Job #11-222-P

May 31, 2013

**Stability of Planned 1½:1 Cut Slopes, Proposed Residential Developments
Cielo Ridge, Off Del Dios Highway, San Diego County (A.P.N.'s 265-300-02, -05, & -03)**

PRELIMINARY GRADING PLAN
FOR COUNTY OF SAN DIEGO TRACT NO. 5456-RPL2
A 19 LOT SUBDIVISION

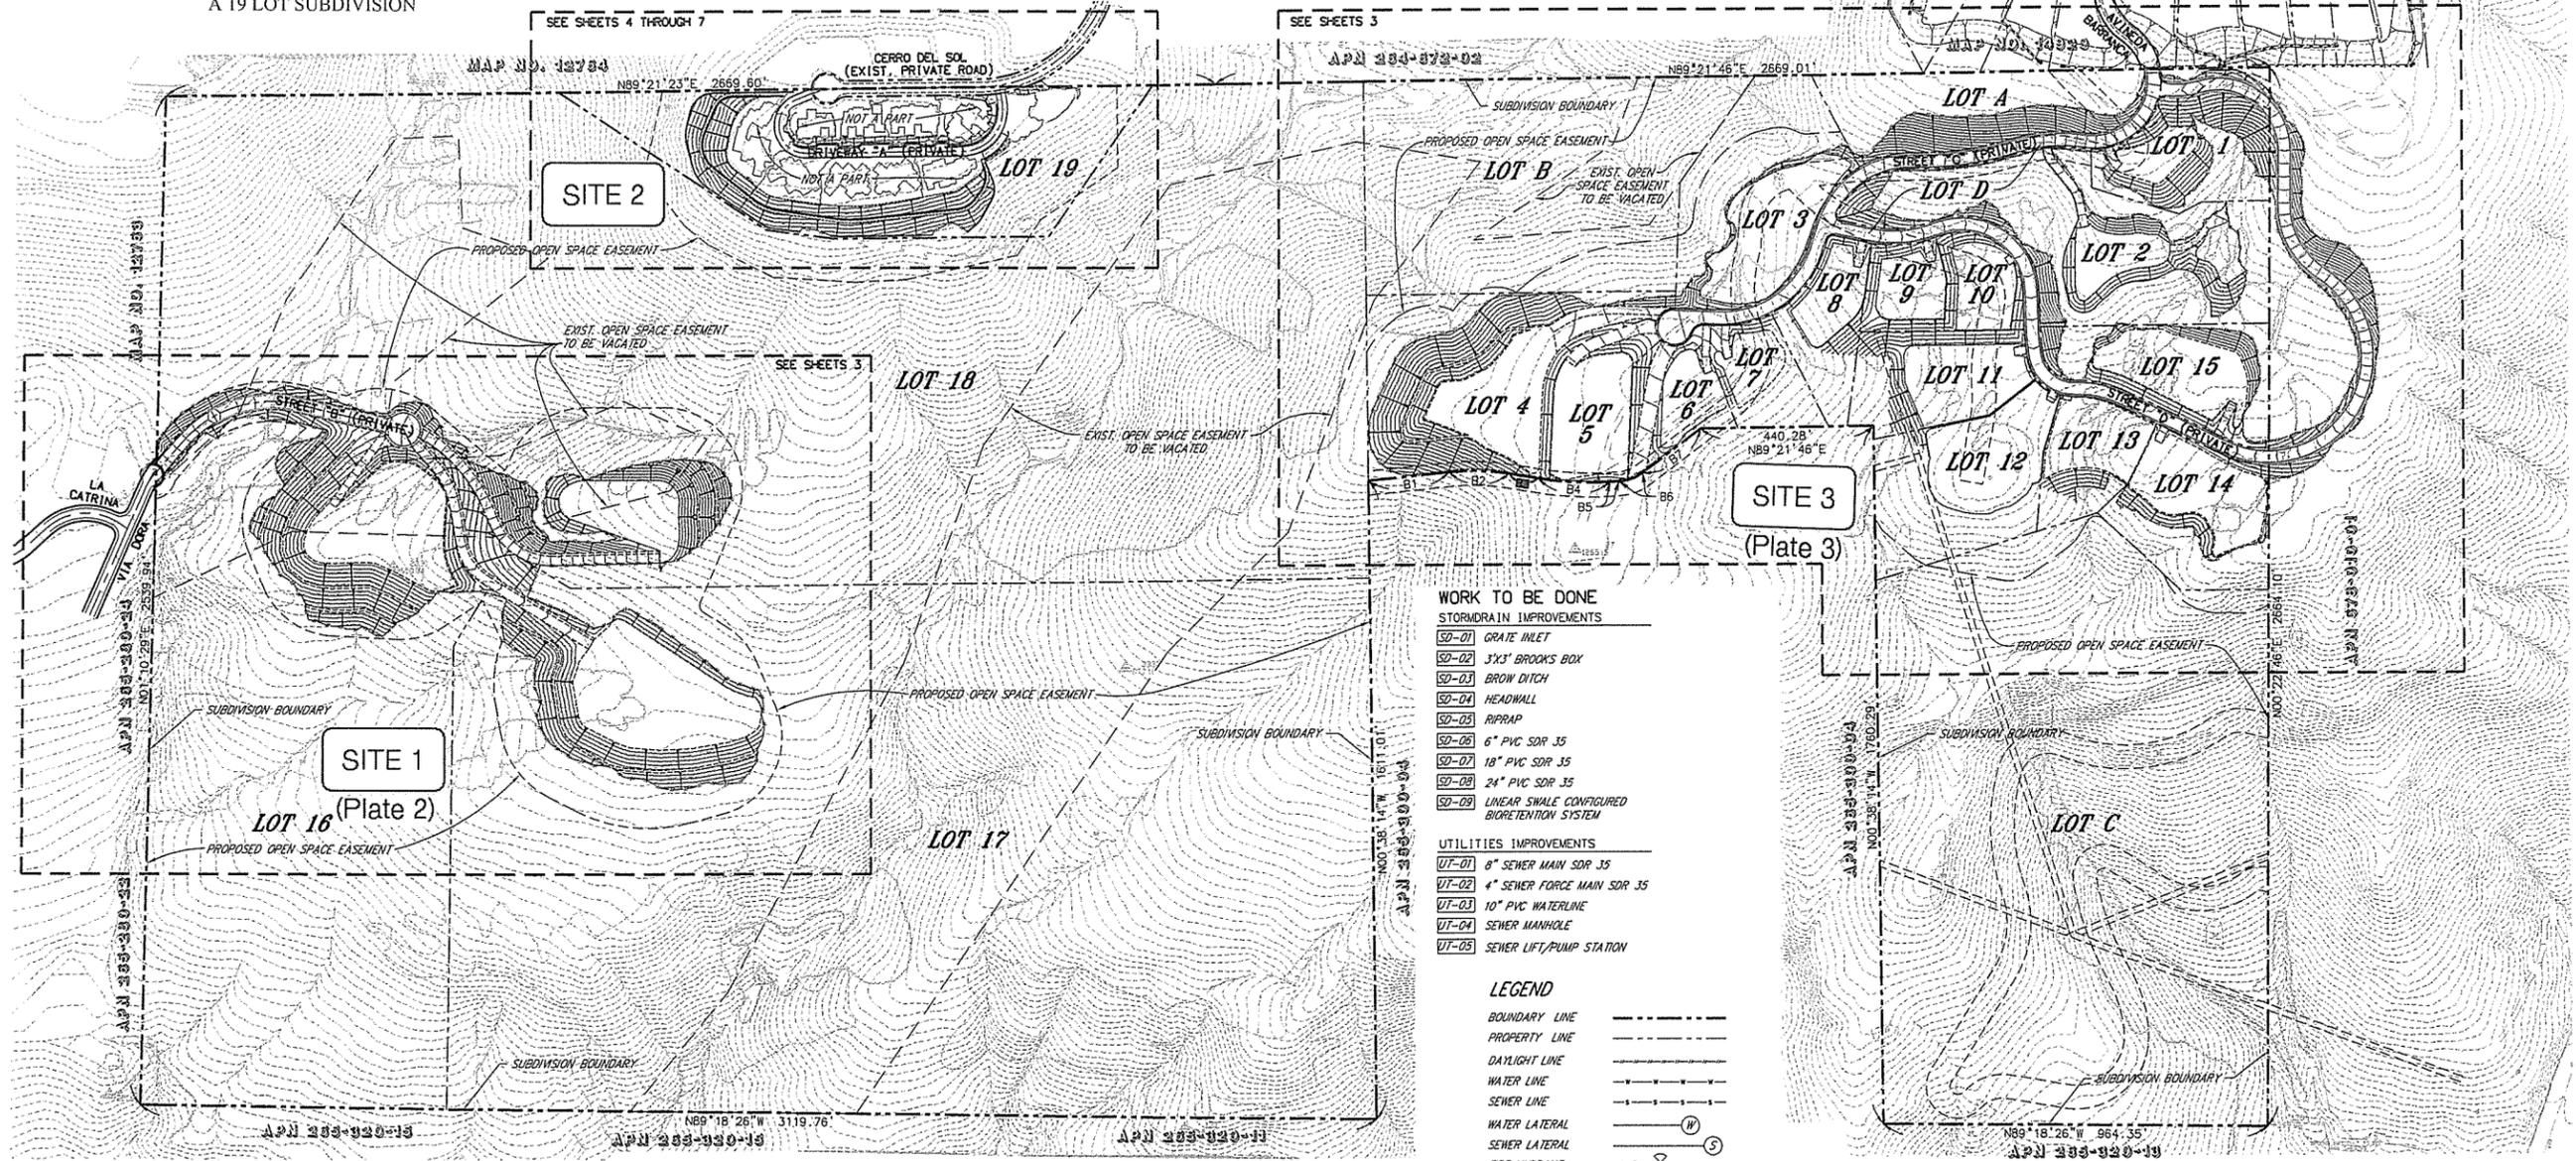
The properties studied for the referenced report include three separate locations designated as Sites 1, 2, and 3, and are indicated on a Preliminary Grading Plan attached as Plate 1. Pertinent locations planned for cut slopes generally consist of ridge lines and hillsides with intervening canyons. More detailed descriptions of the individual study locations are provided in the referenced Geologic Reconnaissance Report. Site specific details for the planned 1½:1 cut slope locations are as follows:

GRADING CONCEPT LOTS 16-18

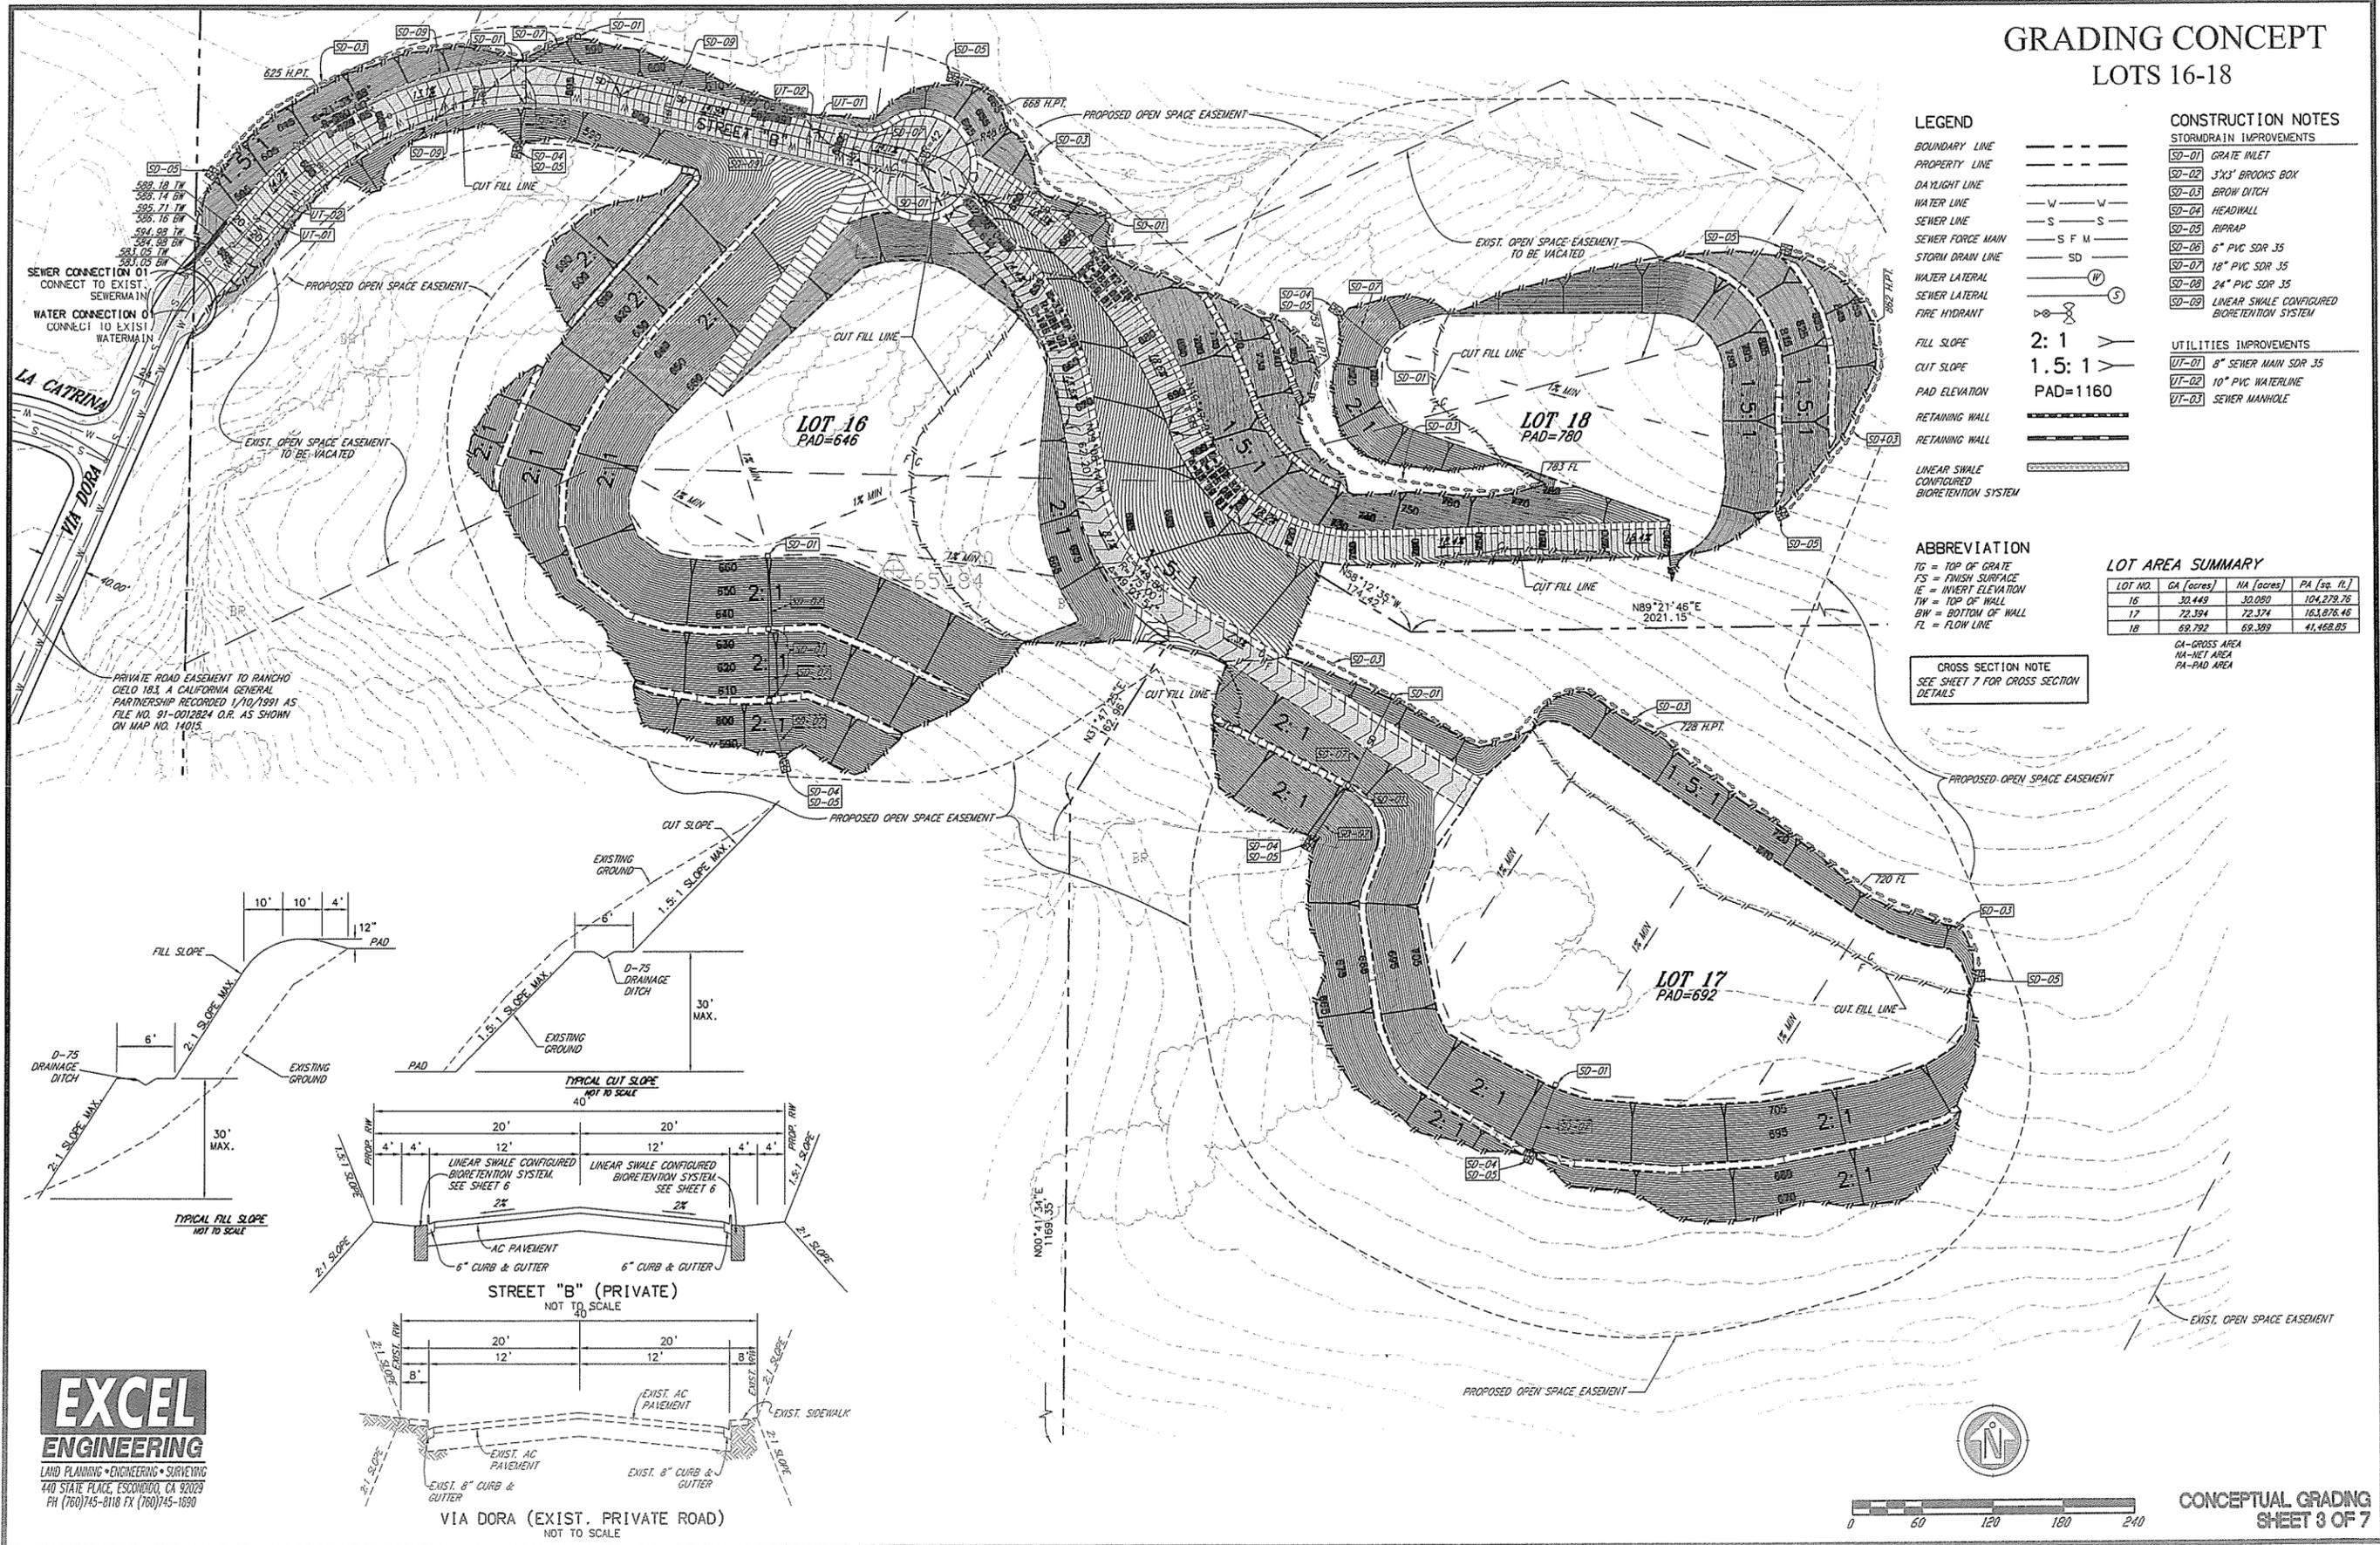
Site 1 (Plate 2): Generally modest cut embankments, approaching 25 feet high maximum, are planned along the entry roadway connected to Via Dora, along the upper, north portion of Lot 17, and between the driveways for Lots 17 and 18. Large, significant cut embankments are planned along the northern margins of the driveway and building pad in association with the development of Lot 18. These cut slopes will approach 70 and 80 feet high respectively, with both having two drainage terraces incorporated into their design. Planned cut slopes within Site 1 are expected to expose hard and competent crystalline bedrock units which will be grossly stable at 1½:1 maximum gradients to proposed design heights. The bedrock is impacted by local jointing which may lead to small surficial block failures. Therefore, a debris fence or elevated curb should be installed along the toe of cut slopes adjacent to roadways or driveways.

3. All graded slopes greater than 35 feet in height, should be provided with a minimum 6 feet wide drainage terrace at a minimum 35 foot intervals or mid-height where only one is required.

5. Well developed concrete brow ditches should be installed along the top of all graded slopes. Runoff shall not be allowed to flow over the slope face. Exposed slopes should be landscaped and well maintained.

GRADING CONCEPT LOTS 1-15

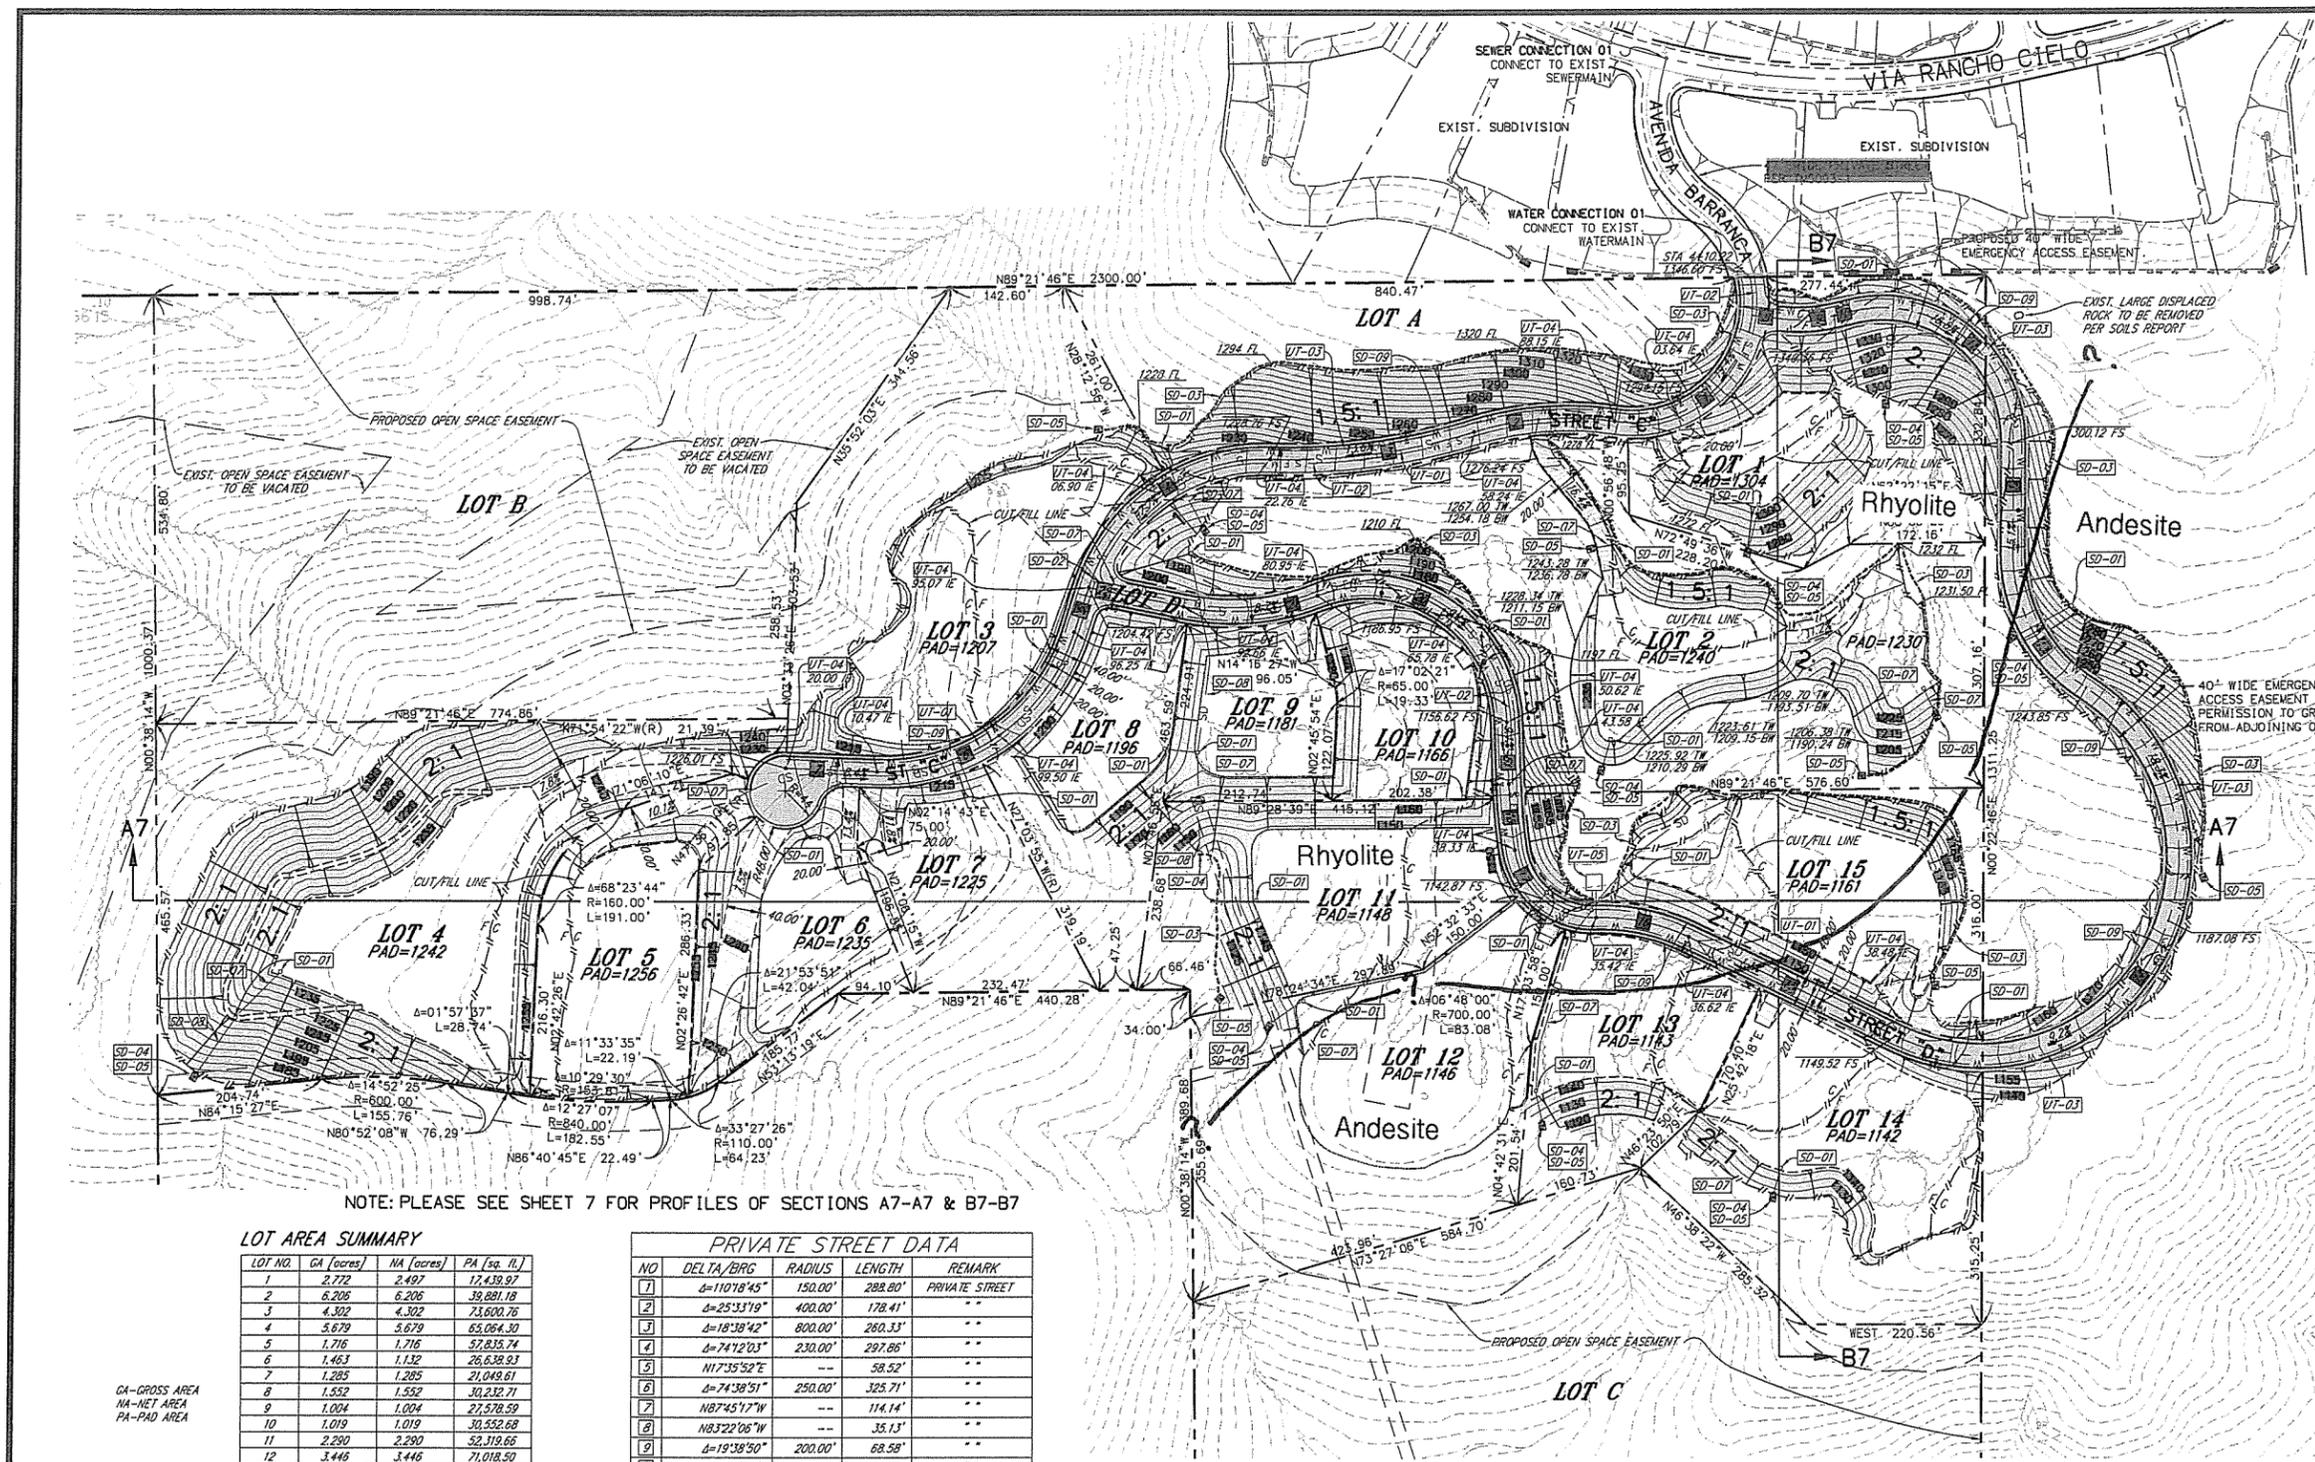
Site 3 (Plate 3): Modest cut embankments on the order of 35 feet high maximum are planned for the upslope portions of Lots 2 and 15. Large, significant cut slopes are planned along upslope portions of Street "C" and Street "D". The planned graded cut embankments along the north side of Street "C" will approach 70 feet high maximum, and graded cut embankments along the east margin of two sections of Street "D" will approach 55 feet high maximum. The current plans (Plate 3) show no drainage terraces for any cut slope within Site 3.

Cut slopes in Site 3 will expose two distinct metavolcanic bedrock types. The approximate contact between the rock types is indicated on Plate 3. In general, the southeast portion of Site 3 is underlain by largely massive, dark-colored andesitic rocks which will be exposed locally along portions of the Lot 15 cut slope and the most easterly section of the Street "D" cut slopes. The remainder of the cut slopes in Site 3 are expected to expose light-colored rhyolitic rocks. Both rock types are expected to be grossly stable at 1½:1 gradients to the proposed maximum design heights with respect to deep seated and surficial failures. However, the light-colored rhyolite rocks are locally mantled by a modest residual soil cover which may indicate the rock is less resistant to weathering and susceptible to surface erosion. Consequently, proper slope face protection with selected vegetation and landscaping will be necessary. Drainage terraces at 35 feet maximum

vertical heights are also recommended, if civil designs allow it. A debris fence or elevated curb may additionally be considered along the toe of cut slopes adjacent to roadways or driveways.
